Subject: 381 N Highland Ave Energy Storage - Ossining, Westchester County, NY
Revised site plan and description of design modifications
20PR02356; Hartgen 5360-31

Att. Plan set, revision date November 4, 2021

PLAN SET
381 N HIGHLAND AVE
OSSINING, NY 10562

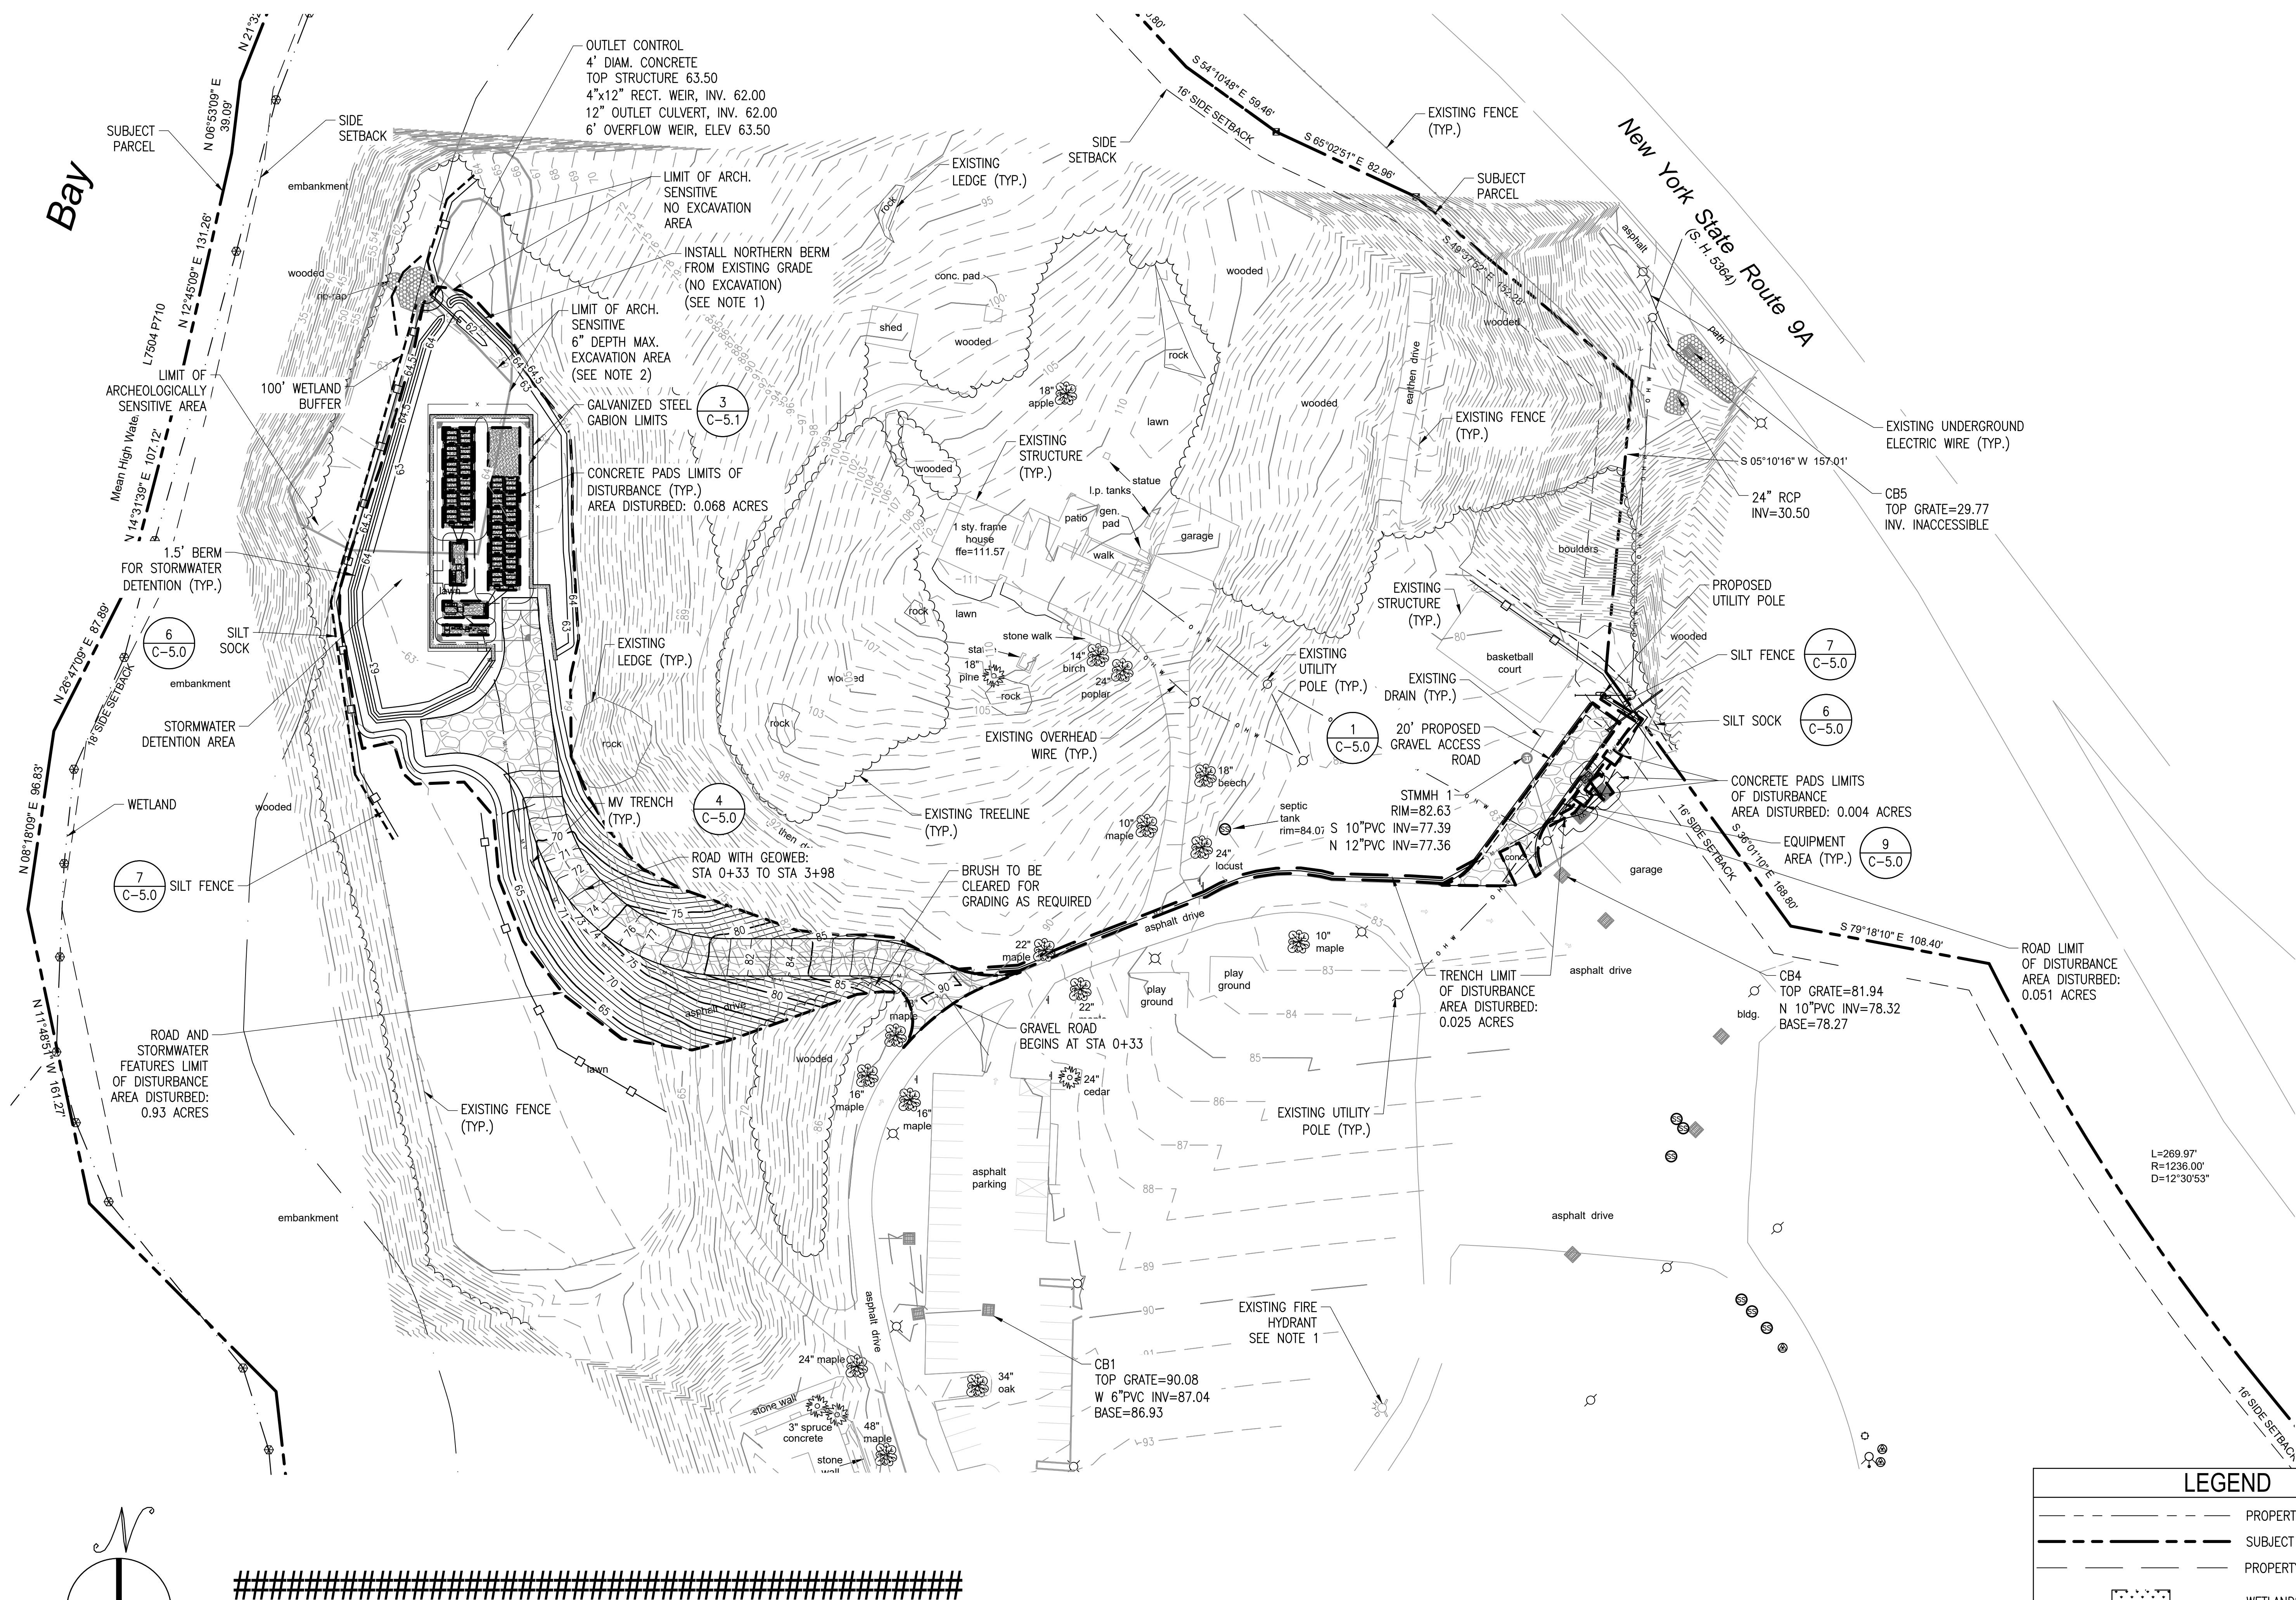
- The western boundary of the APE has modified slightly. In this area, Borrego proposes to place fill in an area already containing fill.
- In the northern avoidance area, the placement of fill has been eliminated with the exception of a small berm along the drainage ditch. No excavation is proposed in this area. Fill for the berm will be placed above current ground level.
- In the southern avoidance area, the grading plan has been modified. Under the current plan, excavation is limited to 6 inches (see detail #3 on page 2 of the attached plans). There will be 3-inch driven fence posts placed every 8 feet along the fenceline, some of which will fall in the avoidance area. No excavation is proposed for the fence posts.

Hartgen recommends that the project plans are consistent with the avoidance plan. The sole action that will occur within the protected site stratum is the installation of a small number of fence posts. Similar to posts for solar panel mounts, Hartgen recommends that this minimal activity does not constitute an adverse impact.
